Joint Meeting of the RID Committee of Experts and the
Working Party on the Transport of Dangerous Goods

Bern, 17–21 March 2014

Comments of the Russian Federation to document ECE/TRANS/WP.15/AC.1/2014/13, prepared by Ukraine

Fig. 3. Installing handling facilities and test valves on the tank model 15-1525:
 1 - gasket, 2, 3 - tubes, 4 - hatch, 5 - Sun 6 - Plug 7 - fitting pressure gauge, 8 - pipe 9 - valve.

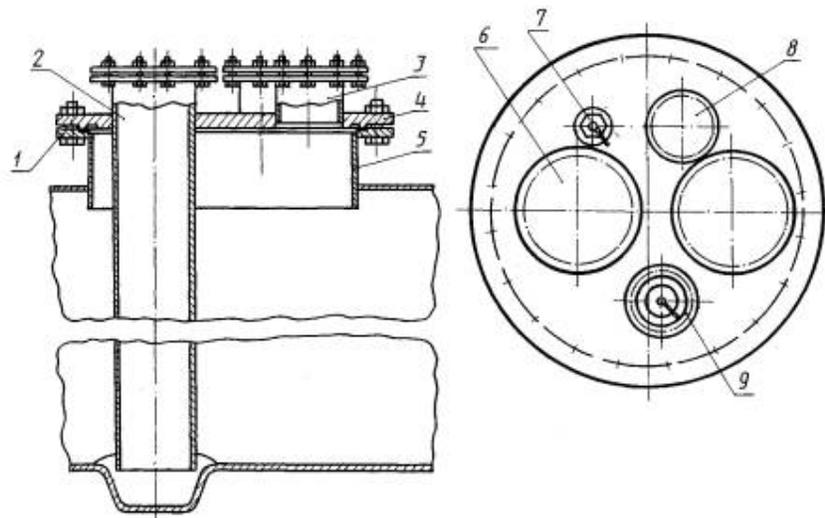
- (a) open the safety cover and remove the plugs from the pipes drain and phosphorus loading and water according to the inscriptions on the flanges;
- (b) open the cap on the nozzle 8 (see Fig. 3) and set the transmitter or other device for controlling the filling;

Fig. 4. Tank wagons for yellow phosphorus Model 15-1525:
 1 - shell, 2 - the bottom, 3 - sun, 4 - housing, 5 - pallet 6 - funnel, 7, 8 - tubes.

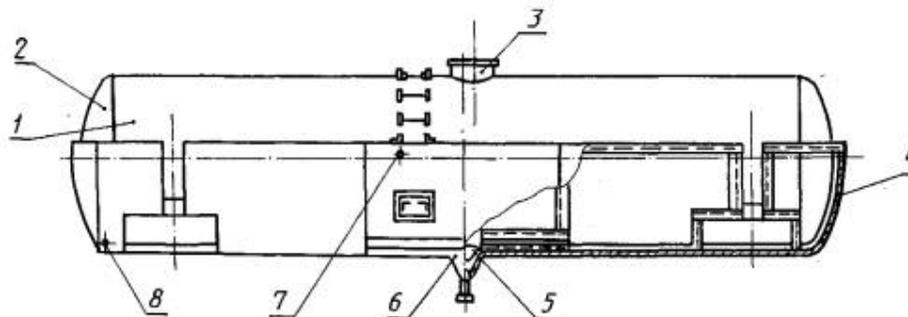
Tank shown in Fig. 4 has a heating-cooling jacket, when used as dispensing, and when discharging the product. Bay water under cooling with phosphorus is performed through one of the nozzles 7, arranged on both sides in the middle portion of the casing. Dripping when heating tank during product discharge through a funnel 6.
